**1395 Rolston Street (COMPLETE APPLICATION)
DP-2025-00882 – CD-1 (887)**

DEVELOPMENT PERMIT STAFF COMMITTEE MEMBERS

DEVELOPMENT PERMIT STAFF COMMITTEE RECOMMENDATION: APPROVE

Figure 2: Proposed Granville Street (West) Elevation with the Rezoning Form of Development massing overlaid.

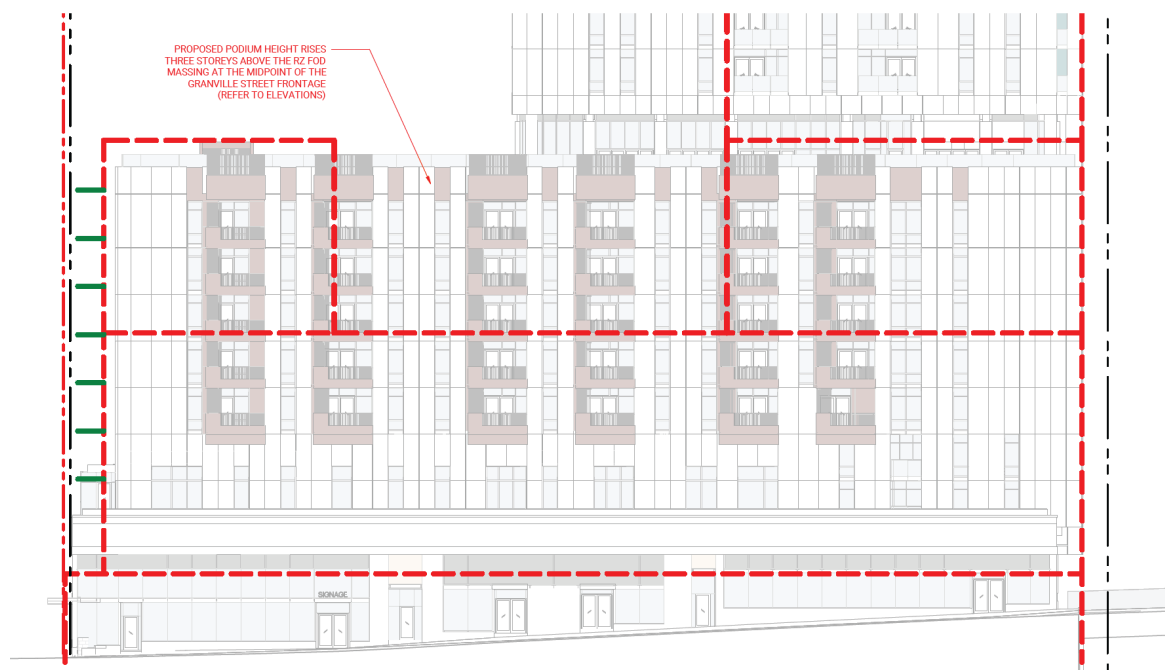
- The proposed at-grade uses align with the urban design intent of the Granville Loops Guidelines and support an active and engaging public realm.
- While the increased podium height results in a modest reduction in perceived openness-to-sky from the street level, this incremental negative impact on the public realm is offset by the greater efficiency gained in the building design which lower construction costs and higher unit-yields.
